STAFF REPORT: DECEMBER 10, 2025 MEETING PREPARED BY: E. THACKERY

**APPLICATION NUMBER: HDC2025-00674**

**ADDRESS: 761 WHITMORE**

SCOPE: ERECT A TRASH ENCLOSURE, ERECT A FENCE, INSTALL AIR CONDITIONER UNITS, AND

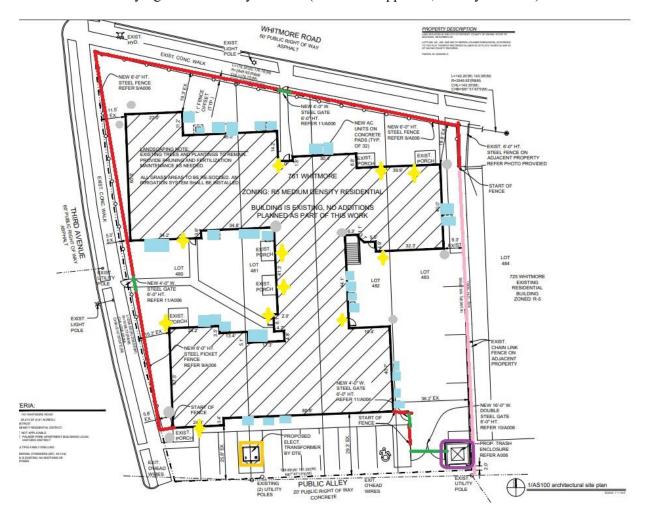
761 Whitmore, building's southwest corner from the south looking north toward Whitmore. A low-walled raised porch with a patio under it, below grade, is visible, and the narrowness of the strip of grass along Third is evident. A 6-foot-high black fence is proposed to enclose this grass strip and run northward to the corner at Third Avenue. The concrete at the bottom of the photo is the alley, and the concrete parking lot for the building is visible just off the alley, next to the building. (Staff photo, November 2025)

Proposed (installed) security lights and cameras and proposed air conditioning units (24"x24" x 33" or 36" tall)

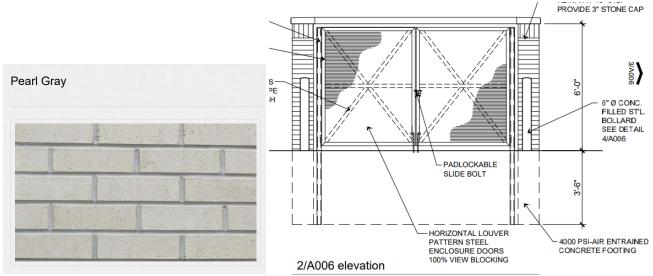
- Staff has authority to approve air conditioning units and fencing in some situations.
  - Regarding the **air conditioning units**, the Commission issued a resolution in 2017 that-gave staff the authority to approve air conditioning units if they are sited (1) "behind the building, OR (2)...on the side of the building (only if a rear location is not possible), and will be fully and continually screened by vegetation or a constructed screen wall, AND (3) the location and screening complies with the requirements as set forth in the city's zoning ordinance." The air conditioning units proposed here would be located in the highly visible yard along Whitmore and prominently lining the courtyard visible from Third, both without screening. Staff believes that in this setting where the property boundary is tight to the building's footprint, these highly visible air conditioning units in these prominent locations would diminish the historic character of the building.

- Installing a 6-foot-tall fence along the two street-facing sides of the property to enclose the narrow strips of grass on this property is not contextually sensitive to the rest of the historic property and district.
- Installing air conditioning units without screening in the highly visible yards along Whitmore and in the highly visible courtyard from Third Avenue will diminish the building's historic character.

• All air conditioning units installed along Whitmore Road and in the courtyard along Third Avenue will be fully and continually screened by vegetation or a constructed screen wall, and the screening will be submitted to staff for review and approval.
